ADDENDUM NO. 1

TENDER NO. 93-19

DOUGALL AVENUE/OUELLETTE PLACE INTERSECTION IMPROVEMENTS

July 23, 2019

PROJ. NO.	18-8905-1000
SHEET NO.	E-3

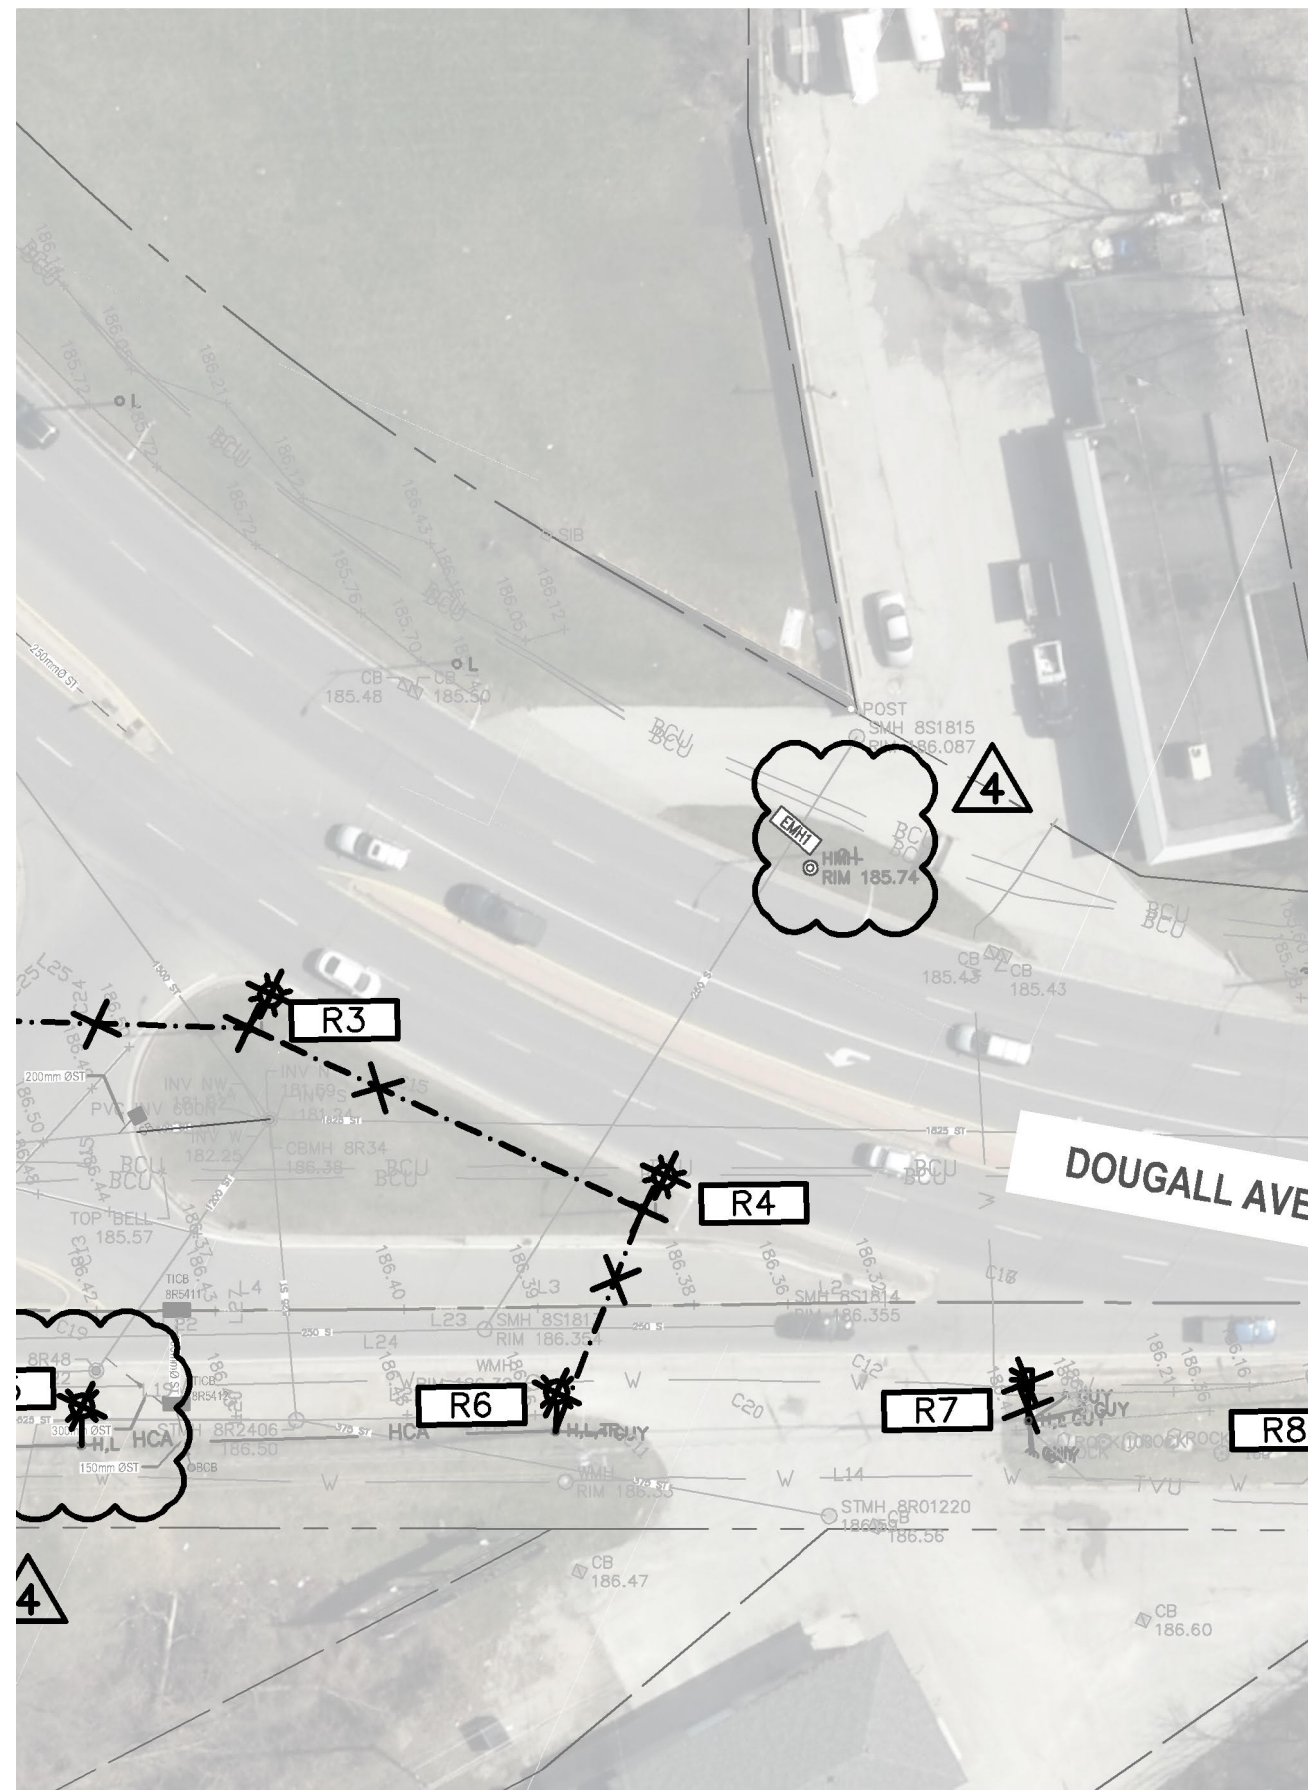
b. Sheets E-1, E-2, & E-3

- Bidders shall replace Sheets E-1, E-2, & E-3 with the attached revision.

The Contractor shall supply and replace existing fixture on EP-3 with new SL-8 (NXT-48M-0-7-2ES-5-GY-3-UL-S-2H-219C)

The Contractor shall supply SL-1 (NXT-24S-0-7-2ES-3-GY-3-UL-S-2H-219C) and EnWin Utilities shall replace existing fixture on EHP-4 with new SL-1.

The Contractor shall supply SL-2 (NXT-24S-0-7-2ES-3-GY-3-UL-S-2H-219C) and EnWin Utilities shall replace existing fixture on EHP-5 with new SL-2.

The Contractor shall supply SL-3 (NXT-24S-0-7-2ES-3-GY-3-UL-S-2H-219C) c/w 3.0m (10ft) mast arm. EnWin Utilities shall install SL-3 and 3.0m mast arm on EHP-6.

Connections for SL-1, SL-2 & SL-3 will be done by EnWin Utilities.

The Contractor shall re-use 3 existing mast arms on TP-1, TP-7 & TP-9 as per the contractor drawings.

The Contractor shall supply and install 2.4m (8ft) mast arm and SL-4, SL-5, SL-6 & SL-7 as per the contract drawings.
